## DEVELOPMENT APPLICATION ASSESSMENT REPORT

<b>Application Number:</b>	DA2019/1280
<b>Responsible Officer:</b>	Lashta Haidari
<b>Land to be developed (Address):</b>	Lot 3B DP 164259, 62 Beaconsfield Street NEWPORT NSW 2106 Lot 4A DP 159498, 11 Queens Parade NEWPORT NSW 2106 Lot 3A DP 164259, 9 Queens Parade NEWPORT NSW 2106 Lot 2 DP 209106, 7 Queens Parade NEWPORT NSW 2106 Lot 5A DP 158658, 13 Queens Parade NEWPORT NSW 2106 Lot 4B DP 159498, 60 Beaconsfield Street NEWPORT NSW 2106
<b>Proposed Development:</b>	Demolition works and construction of a multi unit housing development with associated carparking and landscape works.
<b>Zoning:</b>	R3 Medium Density Residential
<b>Development Permissible:</b>	Yes
<b>Existing Use Rights:</b>	No
<b>Consent Authority:</b>	Northern Beaches Council
<b>Delegation Level:</b>	NBLPP
<b>Land and Environment Court Action:</b>	No
<b>Owner:</b>	Adcock Group Management Pty Ltd
<b>Applicant:</b>	Stable Innovations Pittwater Shores Pty Ltd

**Figure 1 - Showing the relationship of the proposed development with the boundary of No. 58 Beaconsfield Street, (Source architectural plans as amended, prepared by Nettelontribe)**

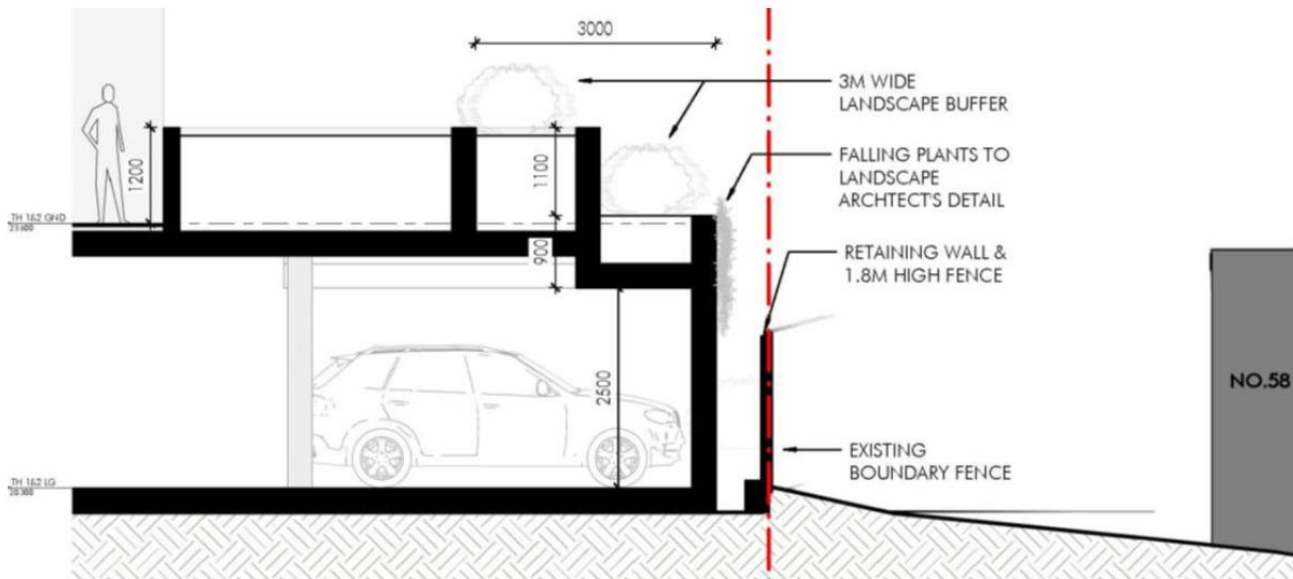
The proposal provides for carparking adjacent to the rear boundary of 58 Beaconsfield Street. The carparking is set below the level of the subject site at RL20.3, such that it is approximately at the same level as the rear yard of 58 Beaconsfield Street.

The proposal as originally submitted to Council, proposed that a garden terrace extend over the carparking at a level of RL24.6, i.e. 4.3m above the level of the rear yard of 58 Beaconsfield Street. The proposal (as amended) steps the raised landscaped area down as it nears the boundary with 58 Beaconsfield Street. Immediately adjacent to the boundary, the proposal is at ground level, then there is a planter box with cascading plants creating a green wall up to RL23.7, as shown in the following drawing:

The concern raised is noted and is addressed in the amended plans.

**Figure 2 - Building Height Non-Compliance (Source: Statement of Environmental Effects, prepared by Symons Goodyer)**

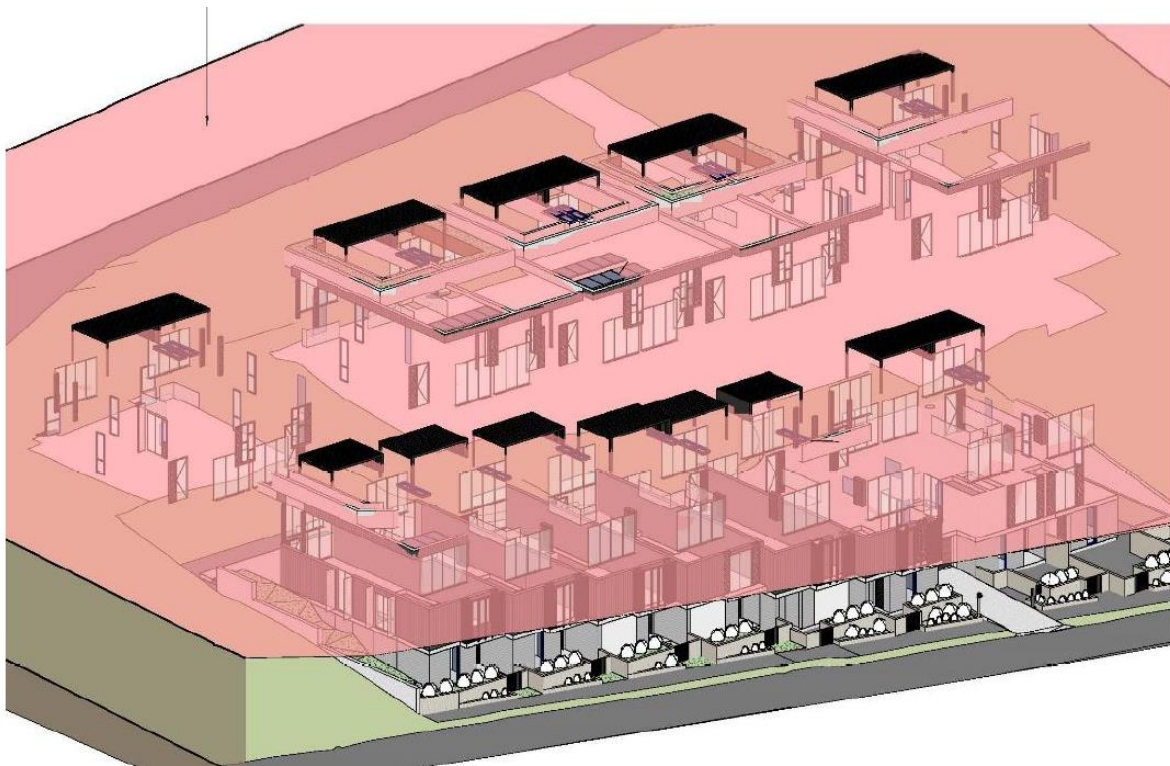
Development Standard:	Height of Buildings
Requirement:	8.5m
Proposed:	Dwellings - 8.5m Canopies above rooftop terraces - 9.6m
Percentage variation to requirement:	12.9%

**Figure 3: Western Elevation - Non-compliance with Side Boundary Envelope, shown in yellow (source: Statement of Environment Effects by Symonds Goodyer).**

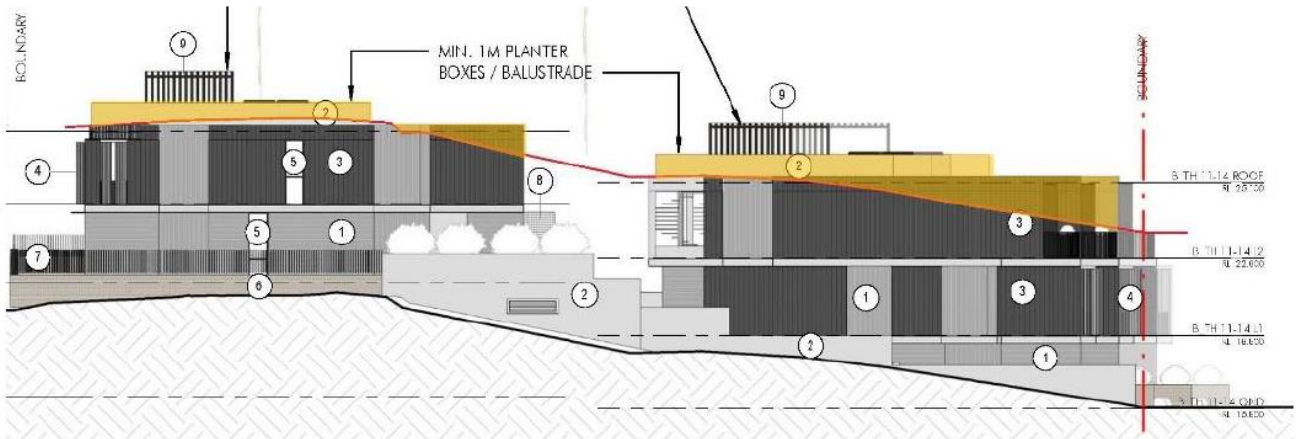
**Western Elevation** - The breach is measured to have an overall length of 23.0m across the two

buildings with an overall height of 1.8m (variation of 75%) as shown in the diagram below (non-compliance is highlighted in yellow).
